Currier Hill, Currier, Oxford

Application No. CUM/80/27-D

Approval of Reserved Matters for a residential development with associated parking, open space and landscaping.

Computer No. 07/01761/REM Officer: Mr Stuart Walker  
 Application Number: CUM/80/29-D Amended plans: Yes  
 Address of Proposal: Timbmet Ltd, Cumnor Hill, Oxford, Oxon, OX2 9PH  
 Proposal: *Approval of Reserved Matters for a residential development with associated parking, open space and landscaping. (Re-submission.)*

Scale **1/100** Date **10/07** Drawn **MP** Checked  
 Job No. **PL061101** Drawing No. **P.189-192.e1** Revision **C**

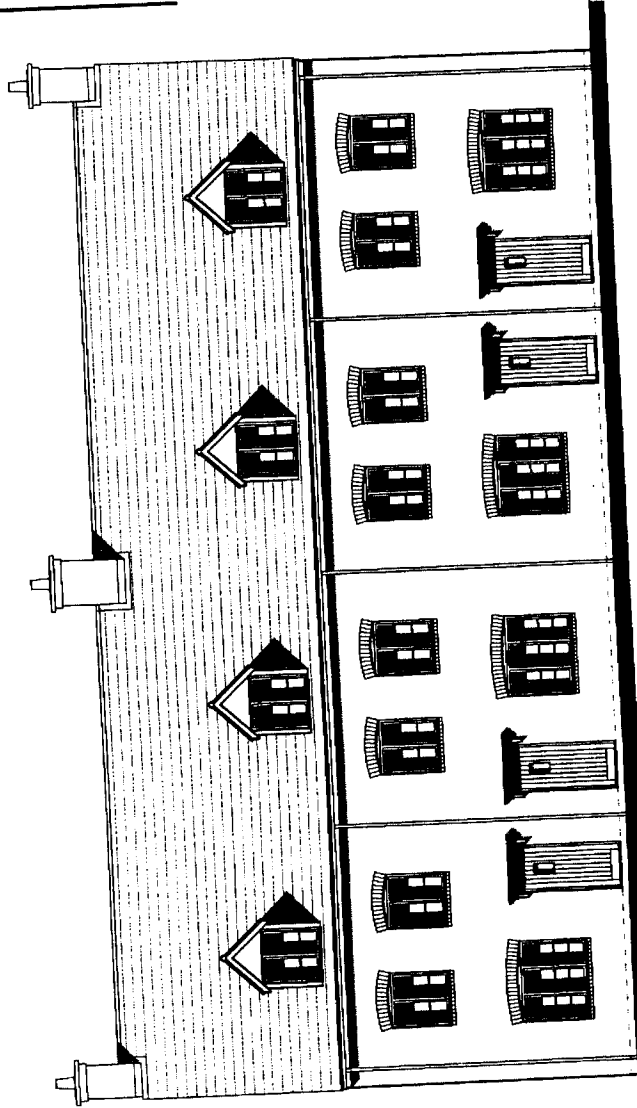
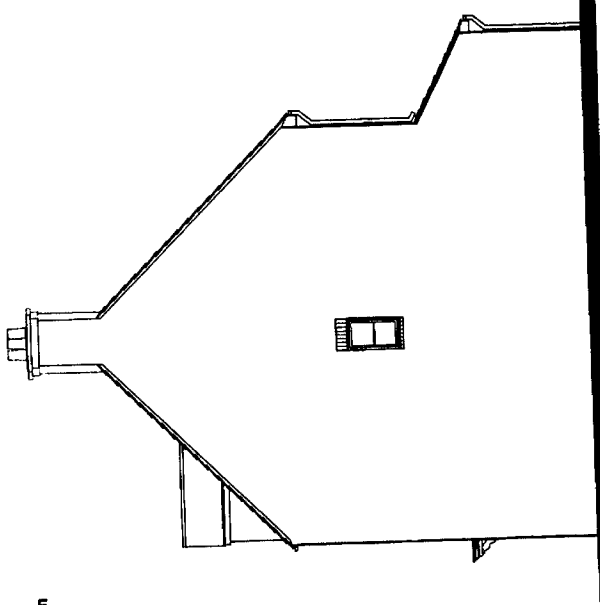
Revisions  
 A 10/07 MP House types corrected to new layout  
 B 11/07 MP Side elevation corrected  
 C 12/07 CP Chimney amended between plots 190-191
